Subject: Draft Revision 2 to Ice Condenser Utility Group Topical Report No. ICUG-001:
*Application of the Active Ice Mass Management Concept to the Ice Condenser
Ice Mass Technical Specification (TAC No. MB3379)*

***Application of the Active Ice Mass
Management Concept to the Ice
Condenser Ice Mass Technical
Specification***

Topical Report ICUG-001, Revision 2

Figure O-1. Ice Mass Surveillance Strategy

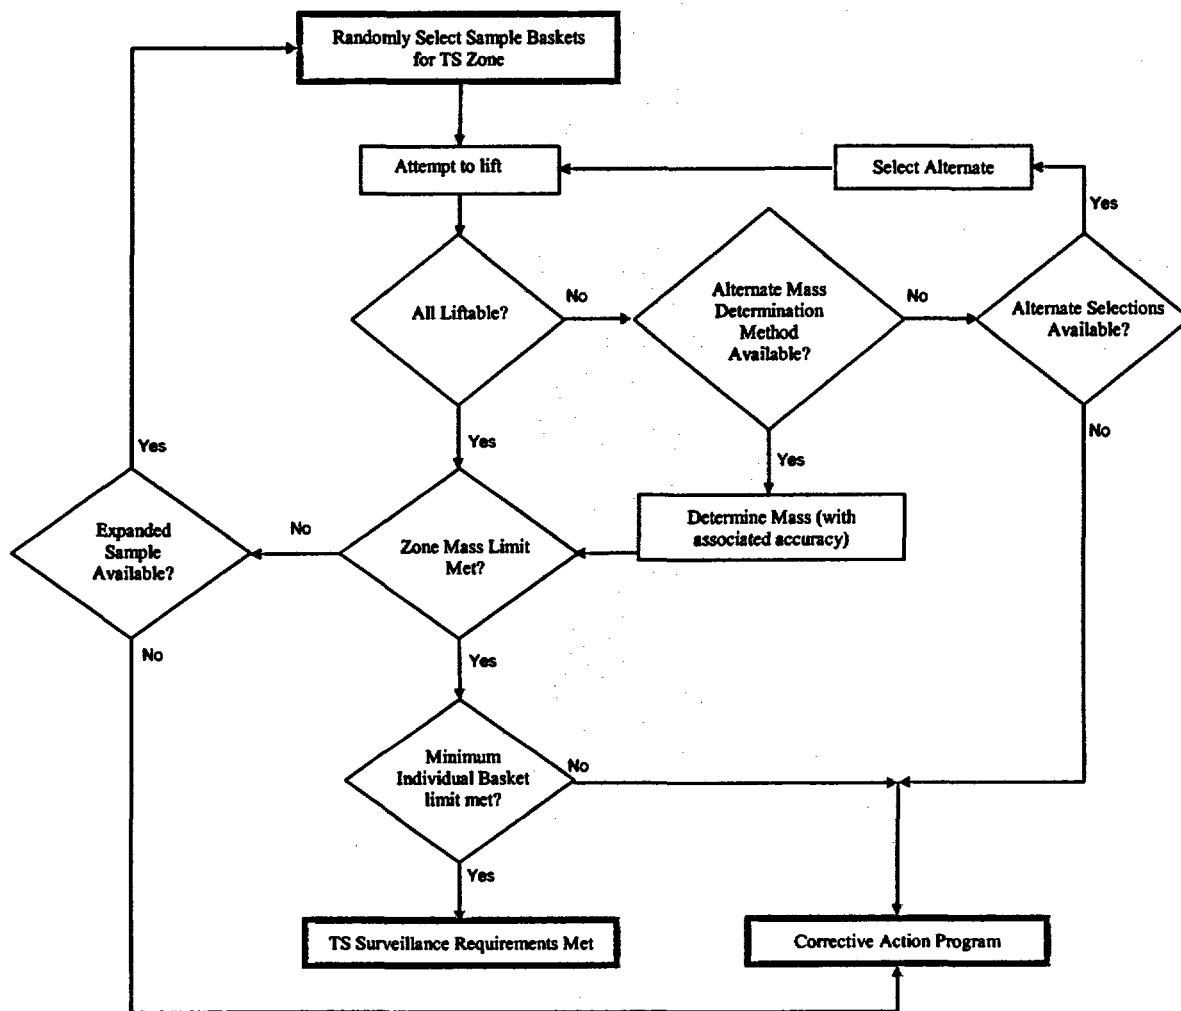
10. Page O-4, Figure O-1: Revised term in flow diagram "Blowdown Limit" to "Minimum Individual Basket Limit" per reference 22.
11. Page O-5, Table O-1: Revised fourth bullet to: "A surveillance for minimum total ice mass in the bed assures the initial conditions of the DBA analyses". Deleted fifth bullet. Revised sixth bullet to: "A surveillance for minimum ice mass in each individual basket prevents localized degradation to avoid any challenge to the DBA containment pressure response". Revised eighth bullet to: "Proper azimuthal distribution of ice in the ice bed is no longer assessed by a separate surveillance requirement; it is implemented through established industry-wide maintenance practices that manage each ice basket above the required safety analysis mean and confirmed through as-found random sampling techniques". Revised ninth bullet to: "All ice baskets in the parent population are subject to random statistical sampling, as opposed to only two-thirds of the population subject to representative sampling." Changes per references 22 and 27.

Figure 1-1. Typical Plan View of Containment Building

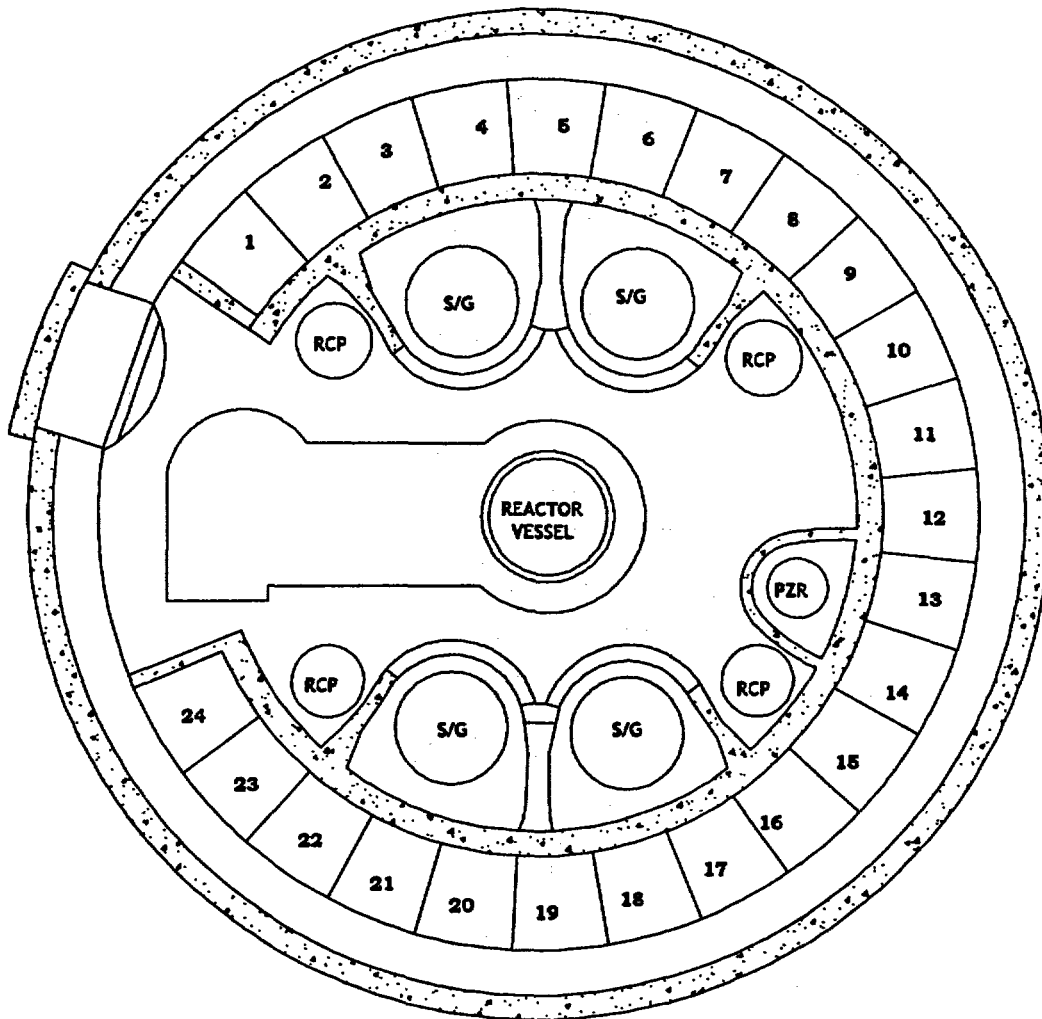
16. Page I-3, Original Ice Mass Technical Specification Requirements: Revised paragraph under Figure 1-1 to read: "In addition, these masses were used as the verification that a degraded localized region did not exist in the ice bed that would challenge the DBA pressure response. If a basket in the 144-basket statistical sample was found to weigh less than the required individual limit (described as "light"), the sample was to be increased in the localized region (i.e., the affected Bay) by 20 baskets. The averaged mass of the 20 additional baskets and the "light" basket was then required to meet the surveillance limit". Deleted reference to the long-term phase of the DBA in the last sentence on the page. Changes per references 22 and 27.
